## SERVICE BULLETIN

AIR - HPC BLEED AIR TUBES - INTRODUCTION OF TUBES WITH CLIPPING LUGS TO SUPPORT  
RE-ROUTED EBU FIRE DETECTION RAIL - CATEGORY CODE 6 - MOD.ENG-75-0050

V2500-ENG-75-0050

Location of HP compressor bleed air tubes  
Fig.1

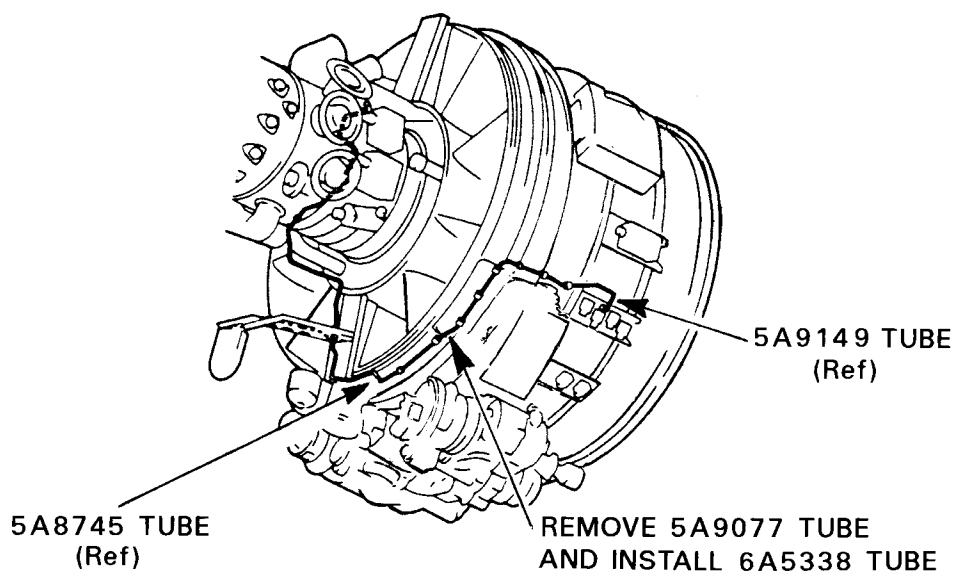
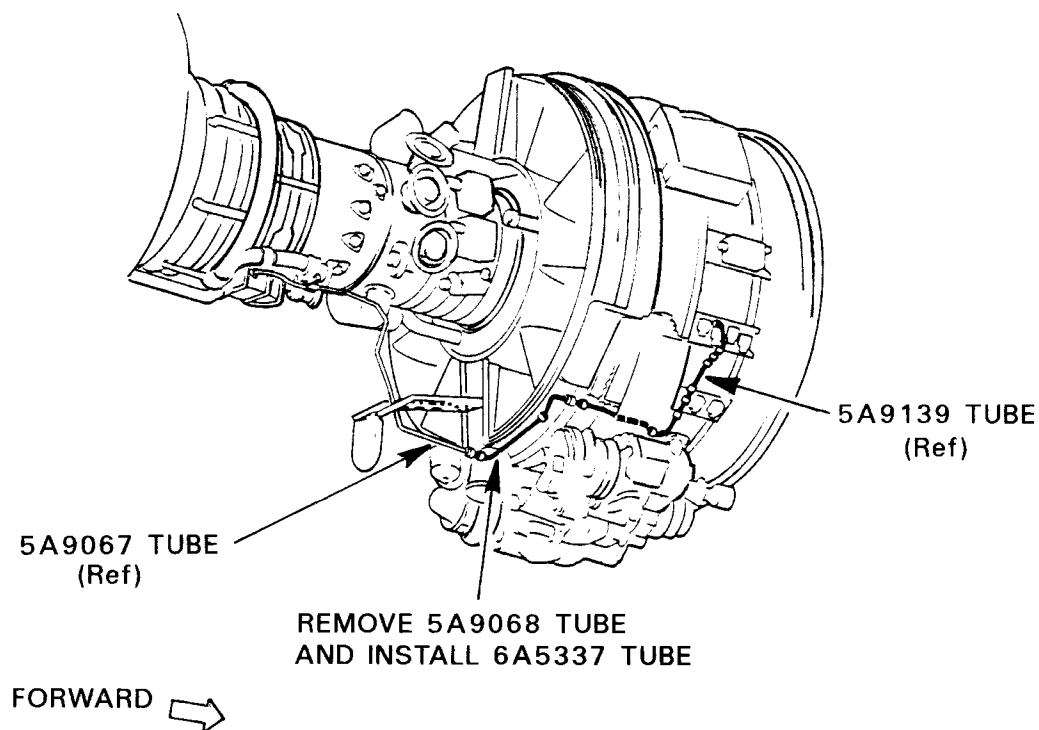
- (1) In the buffer air supply line from the bifurcation panel to the air bleed solenoid valves, the centre tube has two clip support lugs added.
- (2) In the air supply line from the HP7 solenoid valve (51.9 deg.) to the bifurcation panel, the centre tube has one clip support lug added.

- (1) Install the 6A5337 and 6A5338 air tube assemblies in accordance with approved procedures, Engine Manual, Task 72-00-32-420-003-A00 and Task 72-00-32-420-003-B00. Refer to Figure 1 and Figure 2.

Schematic view of HP compressor bleed air tubes - Before and after alteration  
Fig.2

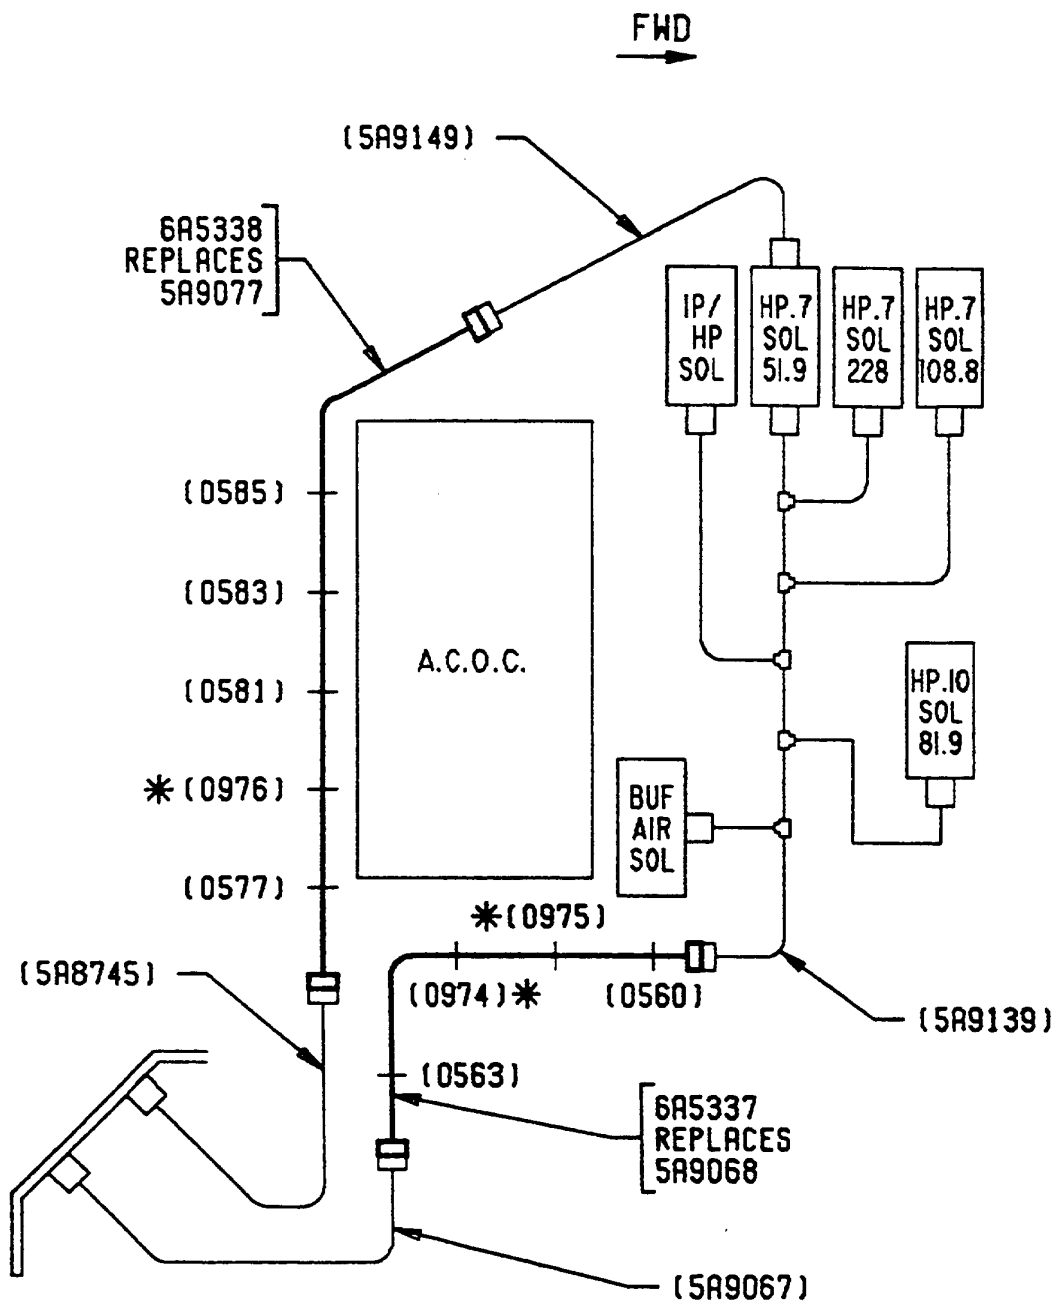
\*ADDITIONAL EBU CLIPS
